LUMINARY Memo # 118

To: Distribution
From: D. Eyles
Date: 27 October 1969
Subject: Landing Changes Put Into LUMINARY 1C

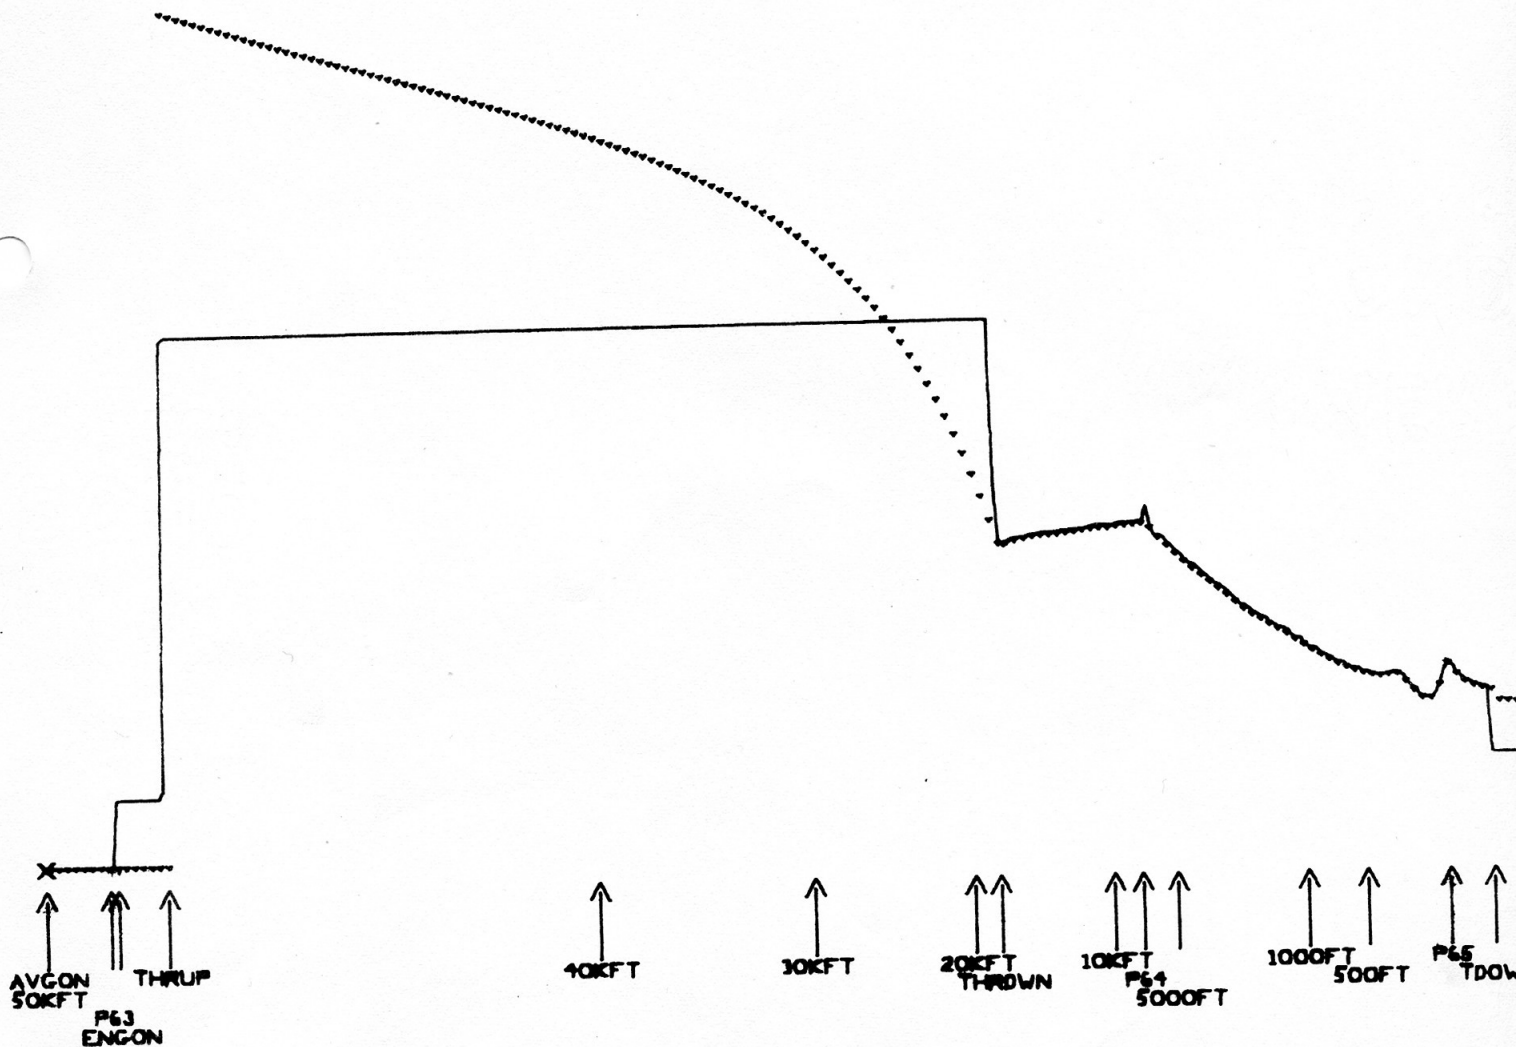
THRCMD is the percent throttle desired by the LGC, based on the DPS rated thrust of 10500 pounds. Half-throttle would look like this: +00050. Thrust and thrust desired for a nominal landing look like this (thrust desired is the dotted line):
